Access Compliance Report

Public Rights-of-Way

(Curb Ramps)

Intersection ID: 49921	Main Street: LESLIE_DR	Cross Street: WANAMASSA_DR	Location: NE
ADA ID: 747106AFCEF8	Ramp Type: BlendTrans1	Initial Pass/Fail: Fail	Overall Compliance: No
Severity Score: 8.75			
Codes/Mitigation Info/Possible Solution		Field Measurements/Component Compliance

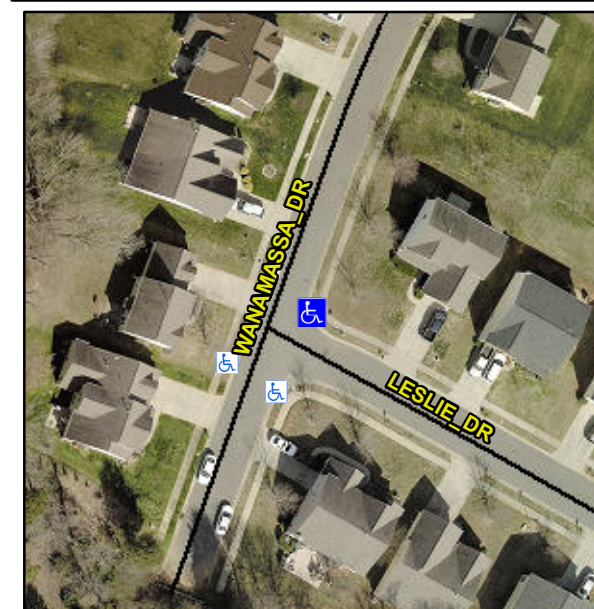
Not Found, R304.5.1

Compliance	Description	Data	Compliance	Description	Data
N/A	Ramp Length (in)	47.0	Yes	BlendTrans Slope (%)	0.1
No	Ramp Width (in)	47.5	Yes	BlendTrans XSlope (%)	0.4
N/A	Flare Type LT	N/A	N/A	Flare Type RT	N/A
N/A	Flare Slope LT (%)	N/A	N/A	Flare Slope RT (%)	N/A
N/A	Flare Traversable LT?	N/A	N/A	Flare Traversable RT?	N/A
N/A	Landing Length (in)	N/A	N/A	DWS Provided?	N/A
N/A	Landing Width (in)	N/A	N/A	DWS Contrast?	N/A
N/A	Landing Slope (%)	N/A	N/A	DWS Length (in)	N/A
N/A	Landing X Slope (%)	N/A	N/A	DWS Full Width?	N/A
N/A	Landing Curb? (Y/N)	N/A	N/A	DWS Offset (in)	N/A
N/A	Shared Landing?	N/A			
N/A	Gutter Ponding?	N/A	N/A	Gutter Slope (%)	N/A
N/A	Gutter Lip Ht (in)	N/A	N/A	Gutter X Slope (%)	N/A
N/A	Painted X Walk1?	No	N/A	Painted X Walk2?	No
	X Walk 1 Direction	To NW		X Walk 2 Direction	To S
	X Walk 1 Width (in)	N/A		X Walk 2 Width (in)	N/A
	X Walk 1 Slope (%)	2.8		X Walk 2 Slope (%)	0.9
	X Walk 1 X Slope (%)	14.0		X Walk 2 X Slope (%)	1.2

N/A	Ramp inside XWalk1?	N/A	N/A	Ramp inside XWalk2?	N/A
	Road Slope (%)	0.0		Clear Space?	N/A
	Road X Slope (%)	0.5	N/A	Clear Space to XWalk (in)	N/A
N/A	Any Obstructions?	N/A	N/A	Storm Grate/Utility Hazard?	N/A
	Obstruction Type			Storm Grate/Utility Type	
		N/A			N/A
			Yes	Surface Condition? (G/P)	Good
			No	Curb Slope (%)	15.8

Remove & Replace Curb Ramp With Two New Directional Ramps or Equivalent.
